Historic Preservation Commission

Wednesday, April 8, 2026

ZHPC-0126-000003 - 1076 Canton Street - Certificate of Appropriateness for a change to the proposed partial demolition plan

CITY OF ROSWELL, GA PLAN CONDITIONS REPORT (ZHPC-0126-000004)

Figure 8. Proposed front elevation (provided by applicants)

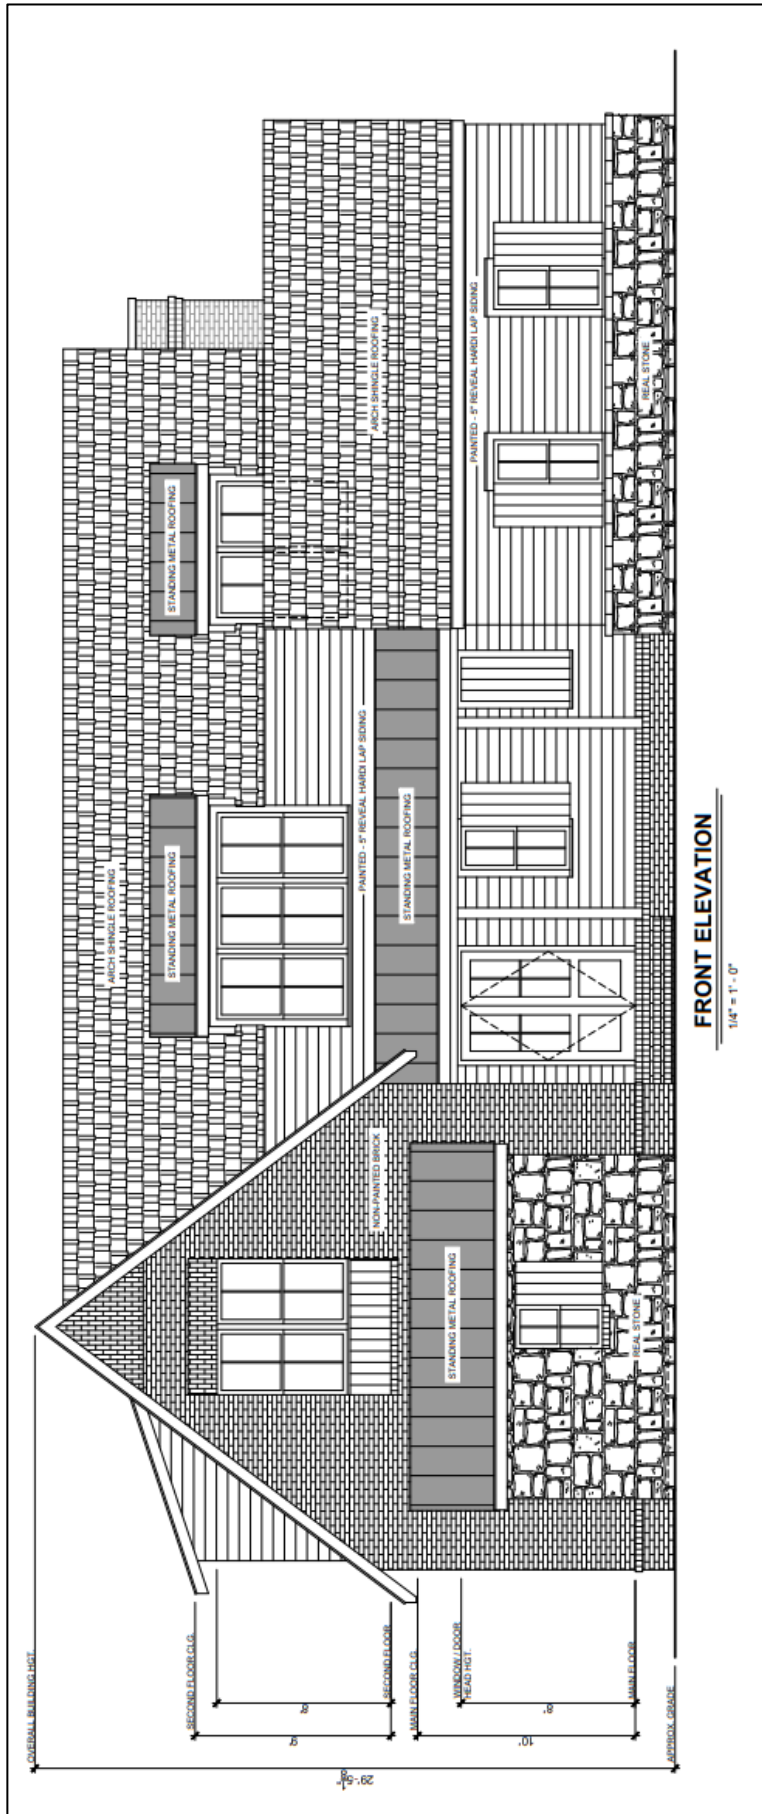
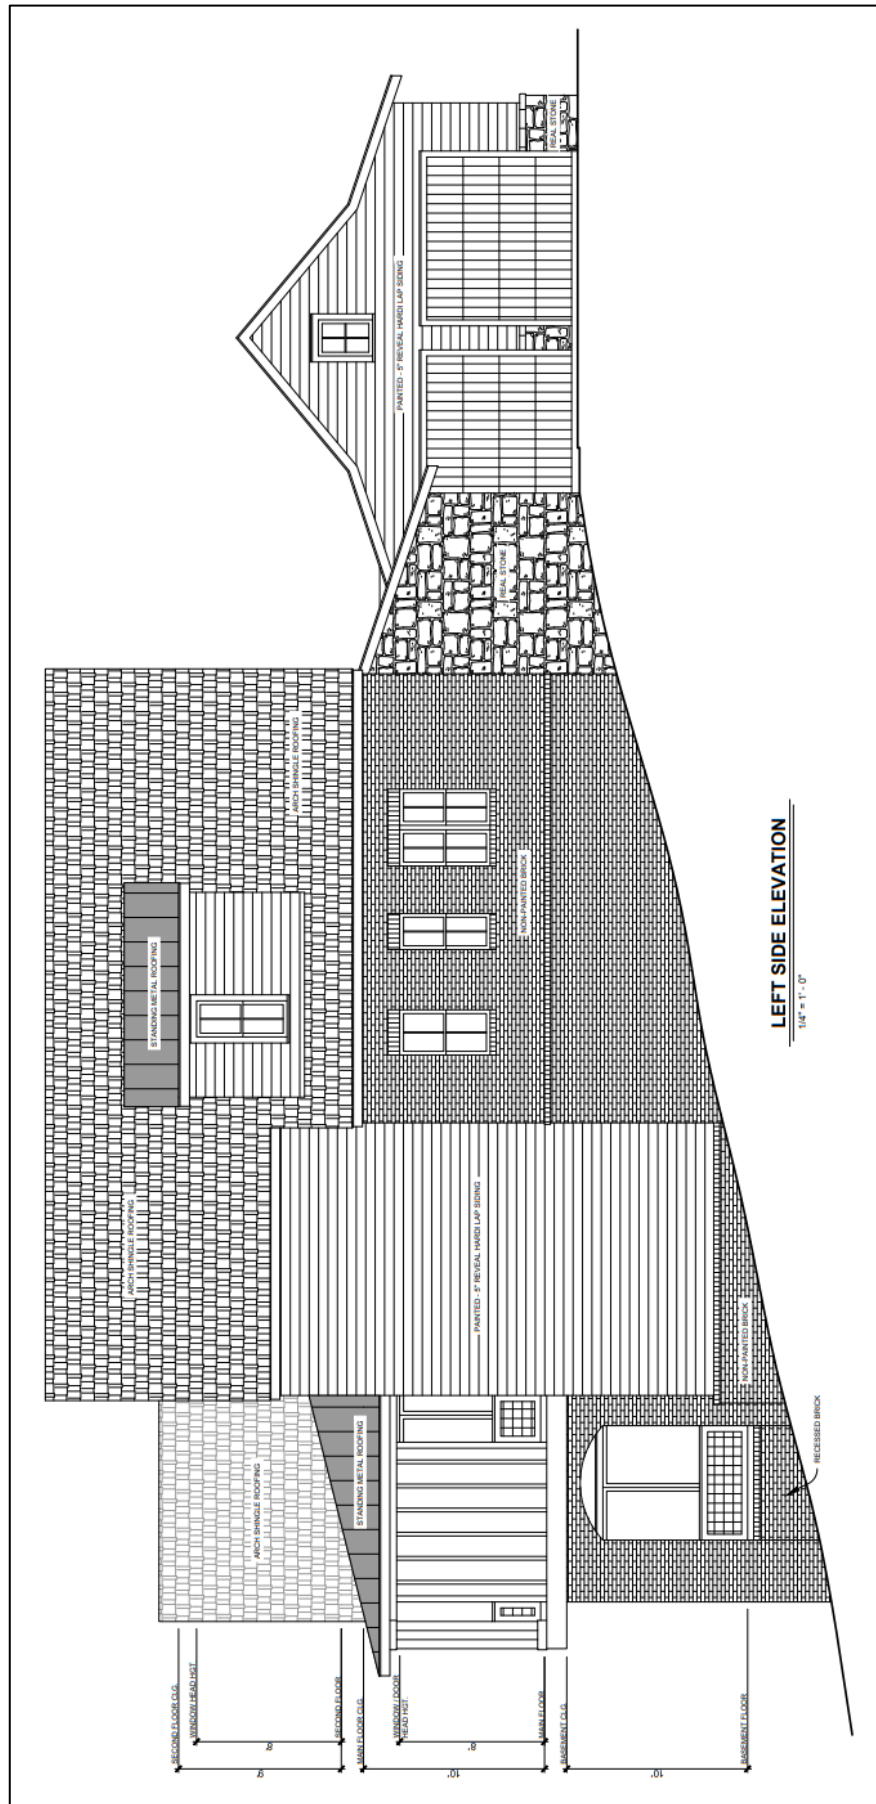
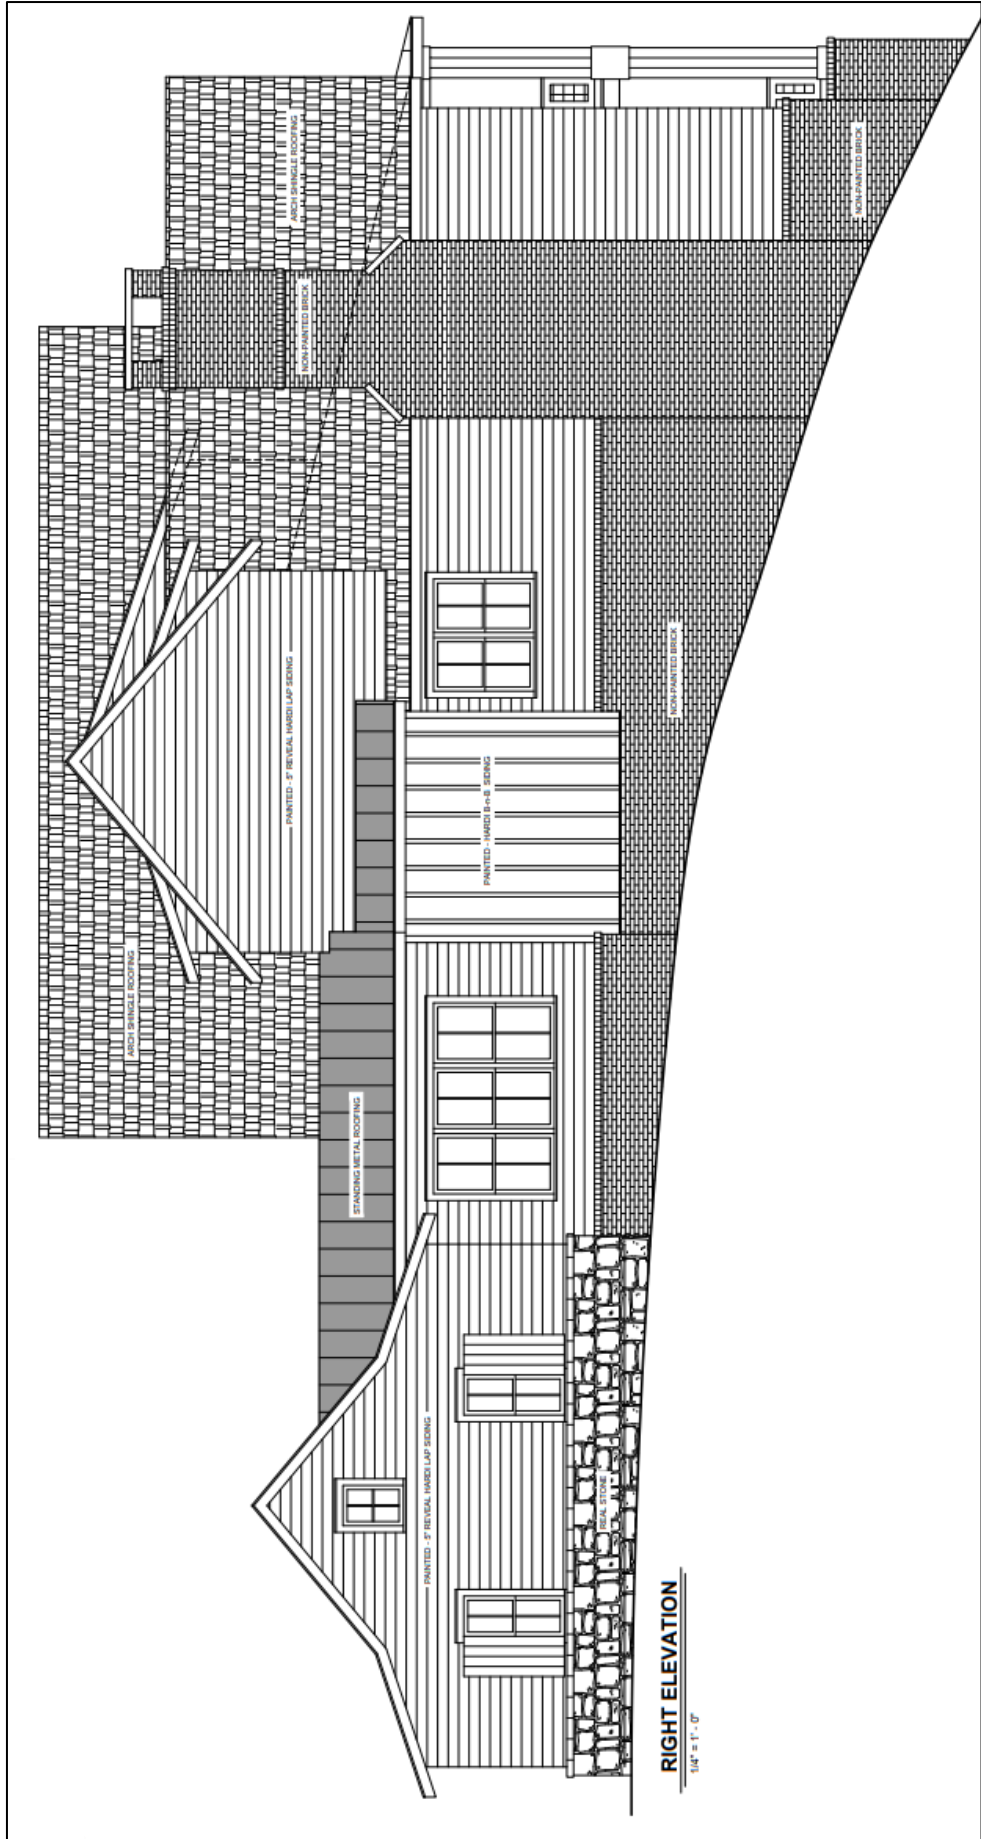
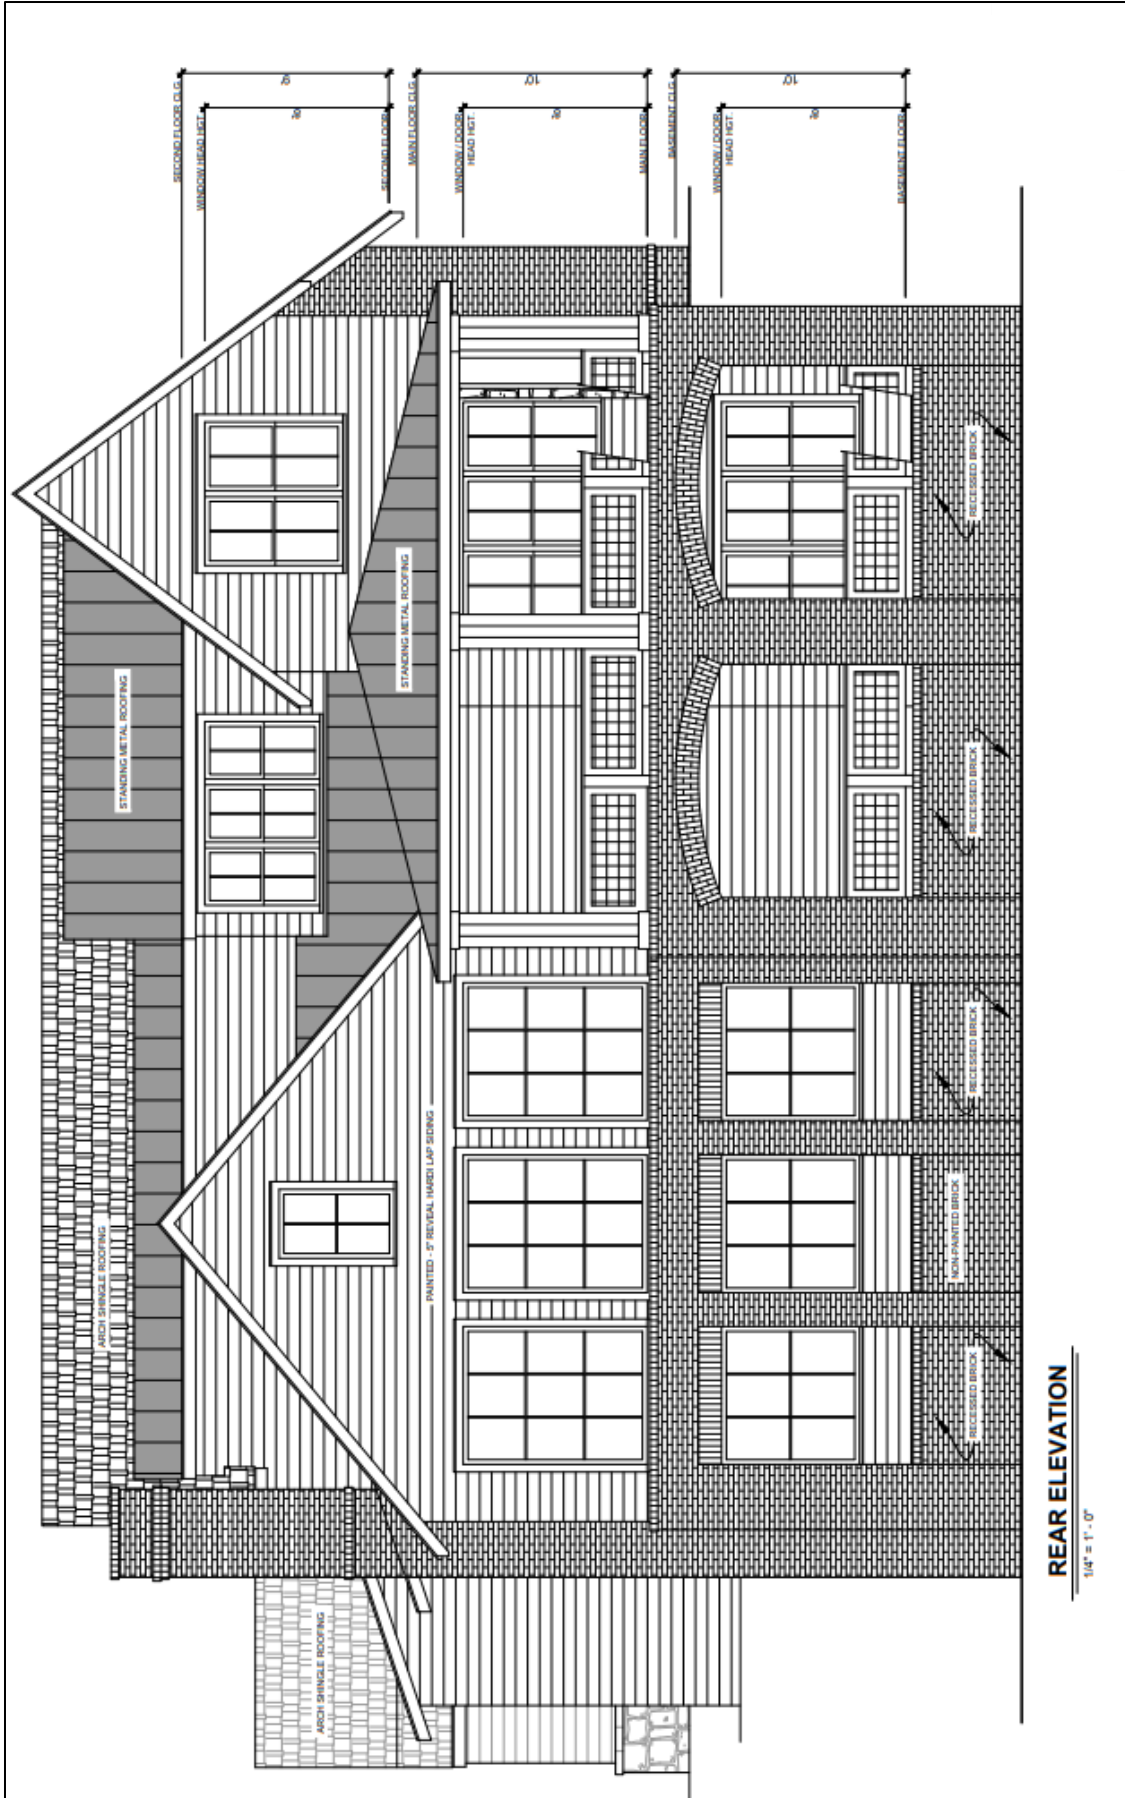
Section 4.24 – New detached houses should be compatible with surrounding homes, especially surrounding historic homes. The current proposal fails to account for traditional building dimensions, or even the building dimensions of newer historic-emulating structures in the Mill Village. The current design includes a garage that extends far beyond the front plane of the house, a total width on the higher end of even newer homes in the Mill Village, and the core residence of the house sitting far back from the street (due to the location of the garages). The design is not compatible with surrounding homes, historic and non-historic.

Section 4.44 – New buildings in the Mill Village should use architectural styles compatible with the Mill Village context. The current proposal does not adhere to this guideline. The structure most resembles the Millenium Mansion style of architecture, which is not a historical style of architecture, and is used sparingly, if at all in the Historic District, and is not used at all elsewhere in the Mill Village character area. The structure is proposed to replace an existing National style structure, a much more common and cohesive architecture style with the remainder of the Mill Village.
